URGENT – Field Safety Notice (FSN)

Product: Encore, Chorus and Sara Plus Standing Aids
Issue Date: May 14, 2012
Type of action: Warnings / Update to Instructions for Use
Ref: FSN003/2012/PHD

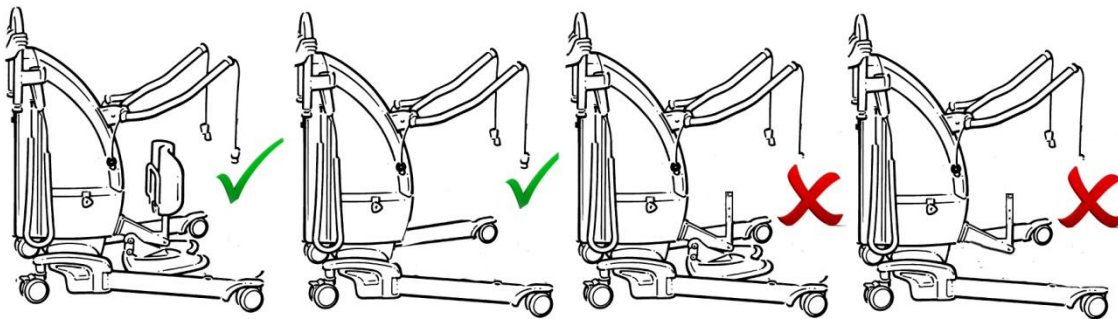
ArjoHuntleigh has recently been made aware of an unfortunate serious accident. During exercise, an Encore Standing and raising aid was used to support the patient to stand. The knee pad had been removed. However the support bracket holding the proactive knee pad support had not been removed as described in the instructions for use manual. This results in a vertical square section end of the metal support bracket becoming exposed.

It would appear that the patient fell onto the metal bracket causing severe trauma. This accident could have been avoided if the support bracket assembly had been removed with the proactive knee pad support.

It has been identified that this issue could occur on 3 similar devices;
The **Encore** (No longer in production)
The **Chorus** (No longer in production)
The **Sara Plus**.

ArjoHuntleigh would like to remind users that the entire knee pad **and support bracket assembly must** be removed when required to do so for exercise.
An additional warning statement shown below will be added to the instruction for use manual and included with future purchases of these units.

The Pro-Active knee pad assembly can be removed to allow exercise. Ensure that when the knee pad is removed, the adjoining support bracket is **always** removed before therapy begins. When refitting, ensure the pad is reinserted, retightened and covers the support bracket.

Failure to do so could lead to serious injury.
